BLDR-2023-28886

PERMIT # OSWP-2023-37462

SEPTIC: IMPROVEMENT PERMIT / AUTHORIZATION TO CONSTRUCT / OPERATION PERMIT / EXISTING SYSTEM

SITE ADDRESS: 924 WESTMINSTER DR, STATESVILLE, NC 28677 PHONE: 704-363-2845 ALT. PHONE:

AS BUILT SKETCH

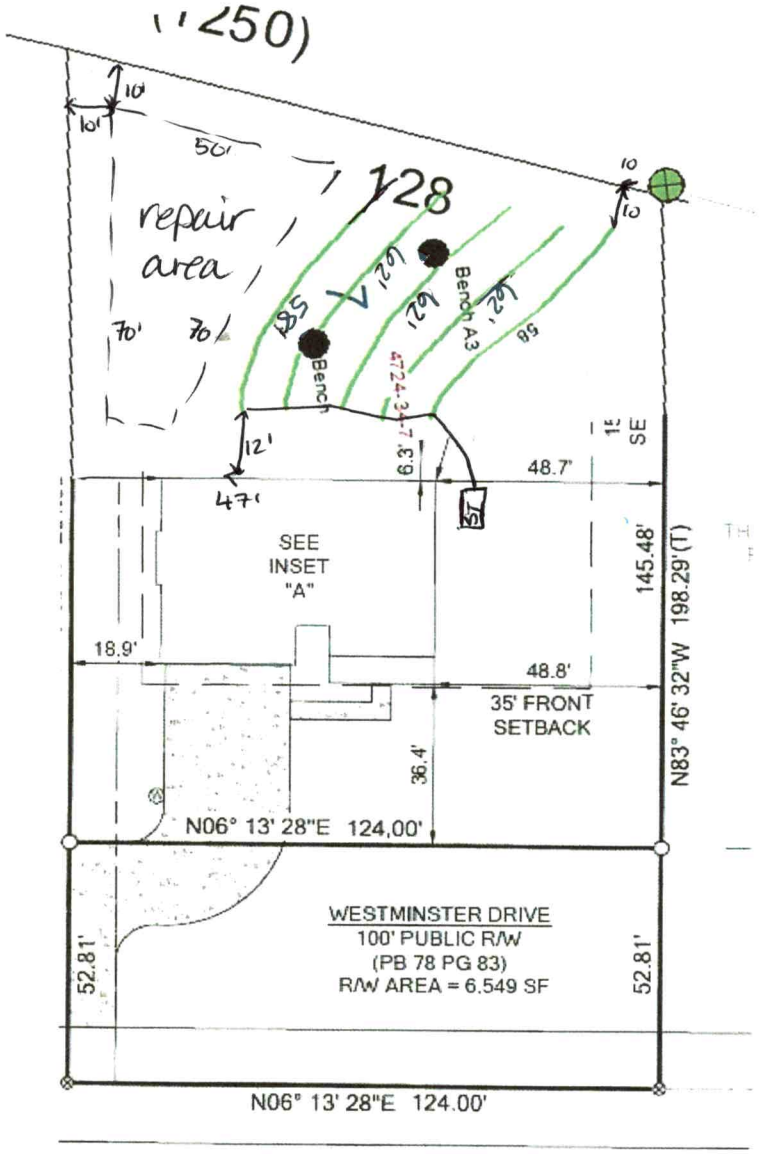
Comments / Conditions: Trench bottom varies across drainfield - remove 6" across lowest 4 lines and have no more than 2' of soil over top of any drain line.

Trench bottom
varies from 20" - 36"

Site plan reflects actual installation - see notes.

verify back of house graded ✓ to drain 10/5/23

Soil graded off drainfield 9/28/23

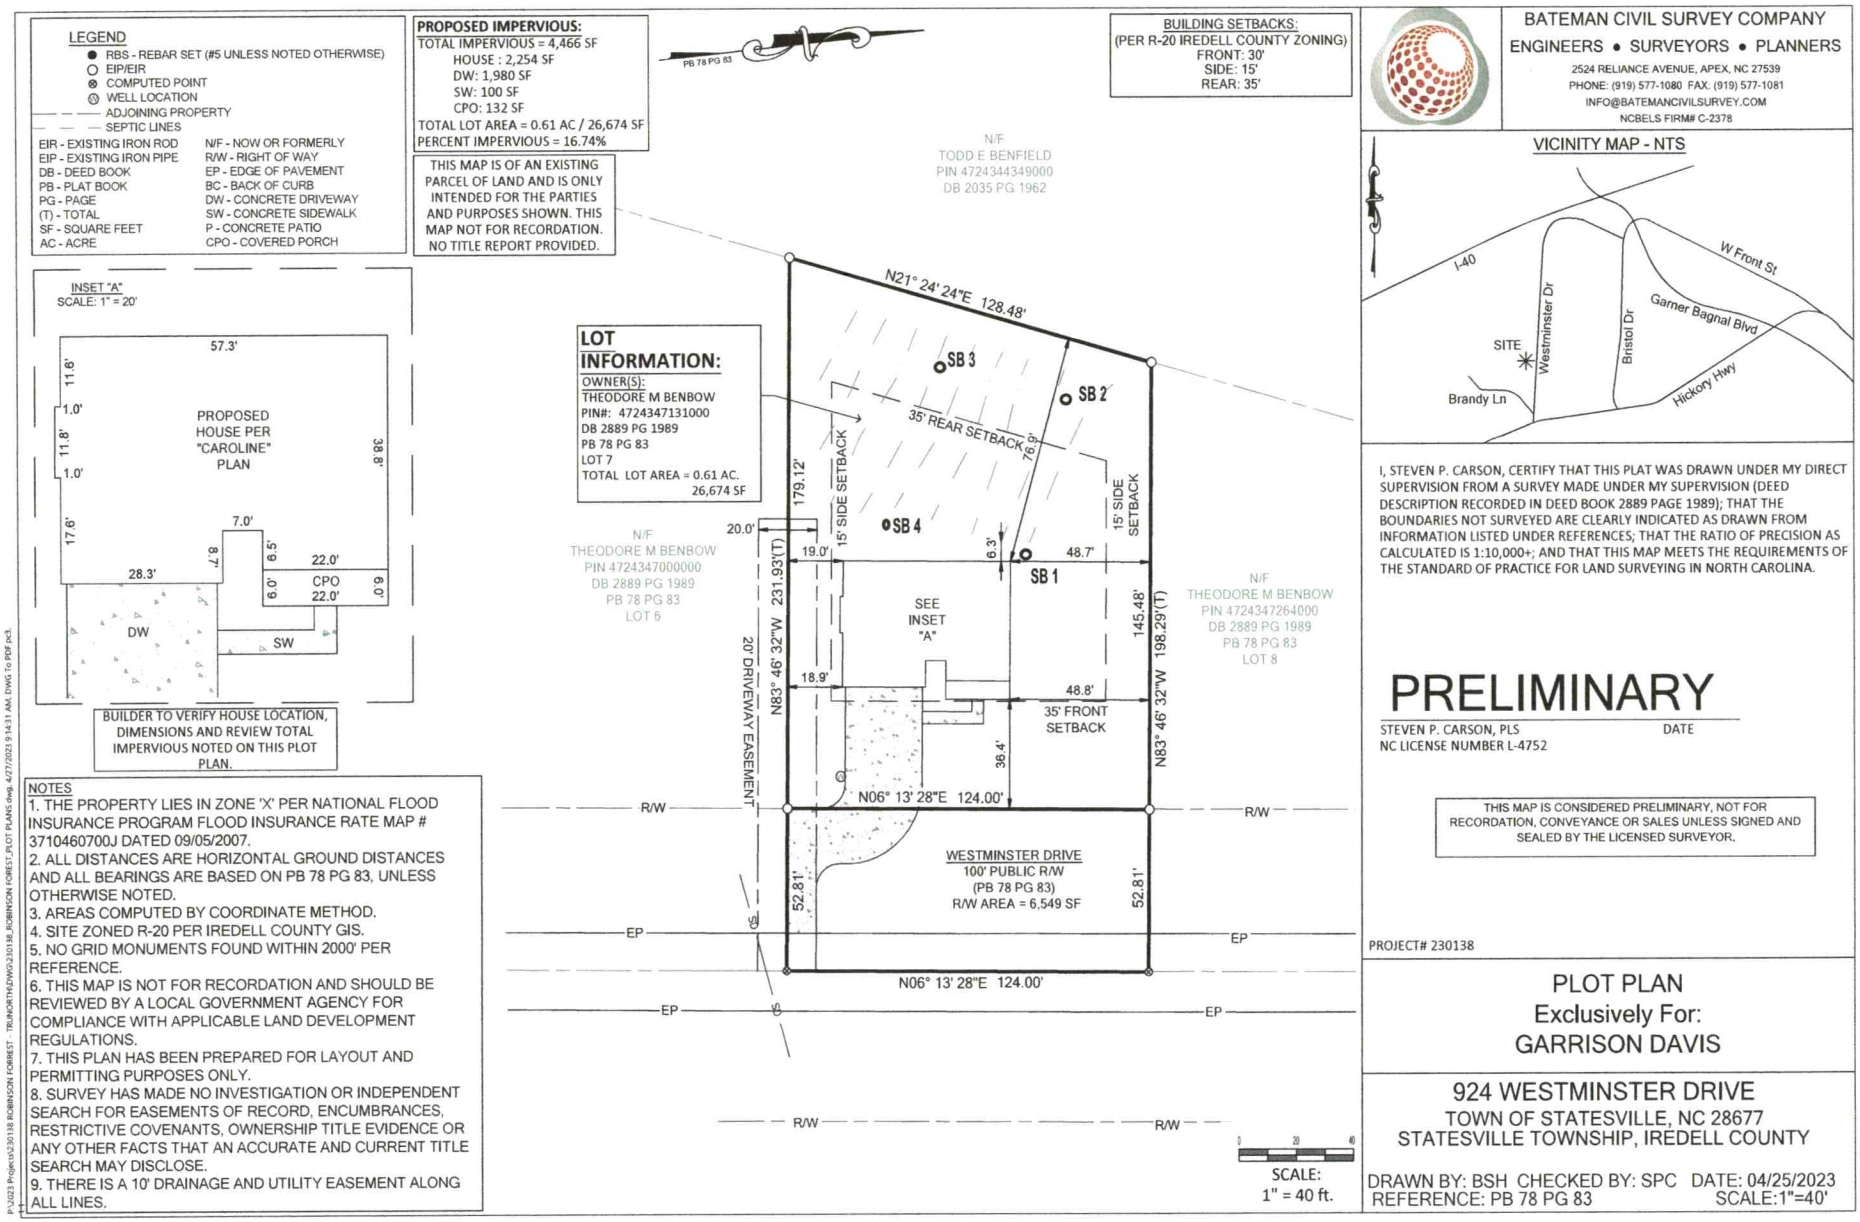
Permit conditions:
The primary septic system has been installed. The infiltrator trench depth varys from 29 -42" Trench Bottoms. In order to "Regain" the 25 % reduction, 6 inches of soil should be removed over the primary drain field area.

The total property area is approximately 0.61 acres. The house and septic area have been cleared. The proposed septic system for the property is a gravity dosed 25% reduction chamber system for initial and a pressure manifold T&J Panel for repair. The primary system has been installed with varying trench bottom depths of 29-42" from the low side of the trench. Six inches of soil must be removed over the septic system area so that the 25% reduction can be granted to the primary system.

AS BUILT SKETCH

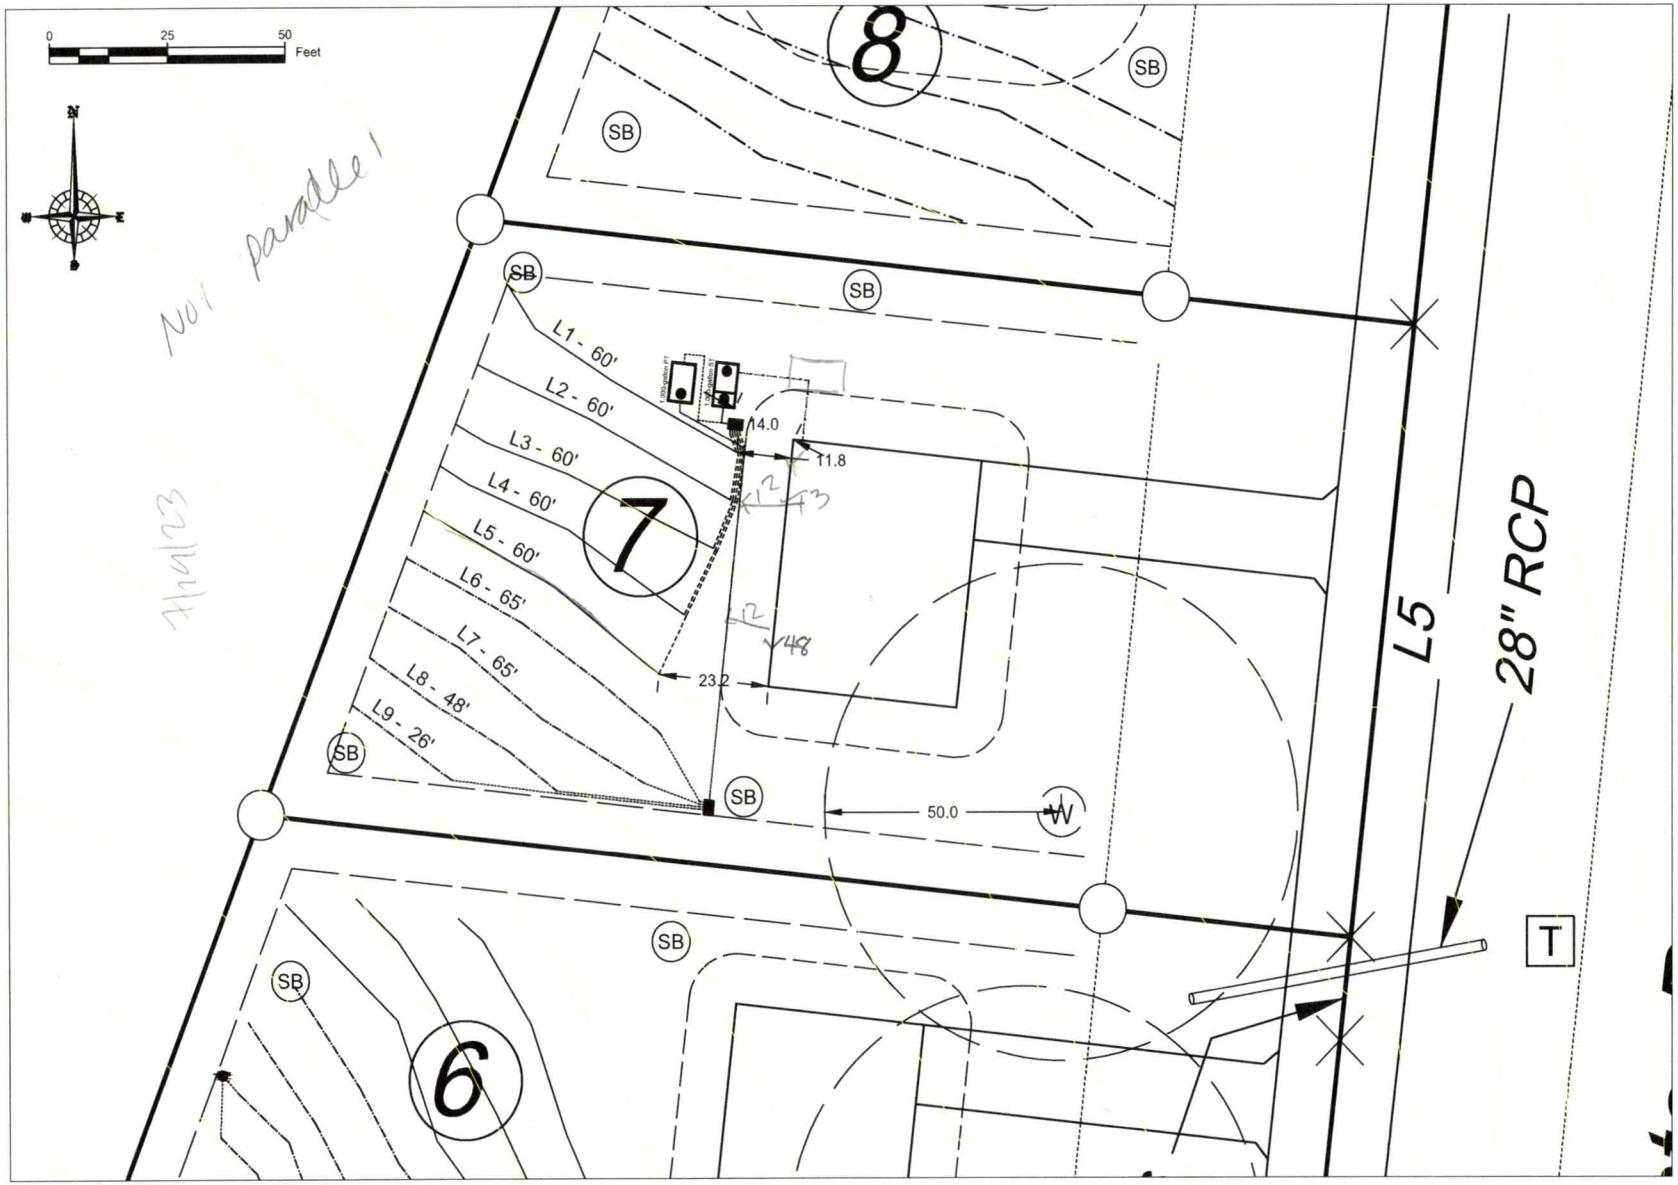
- fill in places at beginning of lines, deeper moving downhill
- will need soil scientist eval before signing off.

- Trench bottom exceeded all lines (low side ranges from 20" to 32")
- Serial fed not parallel

= area w/ 2-4' of fill
